Thank you for purchasing the PG-FP5 flash memory programmer.

This document describes specifications that have been added or changed, restrictions, and cautions on using the PG-FP5. Also see the user's manual of the PG-FP5 for terminology and points for caution on using the PG-FP5.

No. 1 Modification of **Cancel** button specification

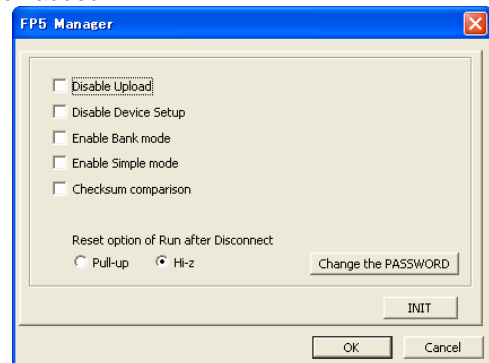
Description: The function of the **Cancel** button on the PG-FP5 main unit has been modified so that cancellation, which was applied to all commands, is only applied to the **Read** command.

Implementation: This item has been implemented in products with control code A (firmware: V1.01, FPGA: V1, GUI: V1.00).

No. 15 Addition of **Wide Voltage mode** function

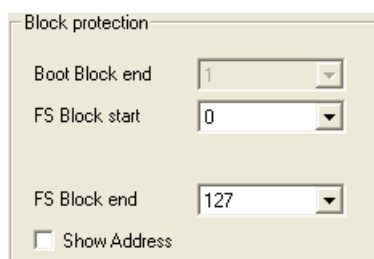
Description: The **Wide Voltage mode** check box has been added to the **Command options** area. If this check box is selected, commands are executed in the wide voltage mode. If this check box is not selected, commands are executed in the full-speed mode. This check box is available when a device supporting this function is selected. For details about the wide voltage mode and full-speed mode, see the user's manual of each device.

Implementation: This item has been implemented in products with control code A (firmware: V2.02, FPGA: V2, GUI: V2.02).

No. 16 Change of layout in **Block protection** area

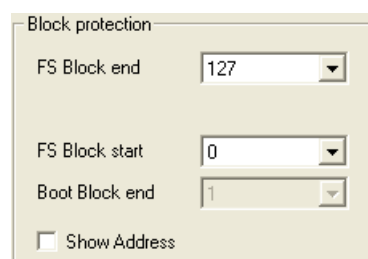
Description: The layout in the **Block protection** area has been changed.

Implementation: This item has been implemented in products with control code A (firmware: V2.02, FPGA: V2, GUI: V2.02).

[No. 26 Writing to 78K0 microcontrollers by using an external UART clock](#)

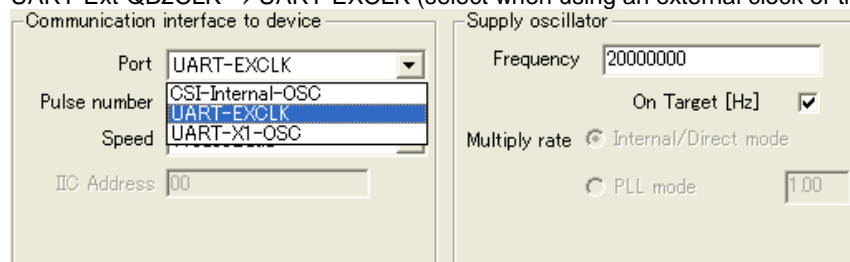
Description: When writing to 78K0 microcontrollers by using UART communication, the PG-FP5 can now perform writing to a target system in which an external clock is input to the microcontroller's EXCLK pin. To enable this feature, select **UART-EXCLK** in the **Port** list box, select the **On Target** check box, and input the relevant frequency to the **Frequency** box.

Along with the addition of this feature, the options in the **Port** list box have been changed as follows:

UART-Ext-OSC → UART-X1-OSC (select when using an external resonator clock)

UART-Ext-QB2CLK → UART-EXCLK (select when using an external clock or the FP5 clock)

Implementation: This item has been implemented in products with control code A, C, D (firmware: V2.06, FPGA: V4, GUI: V2.06).
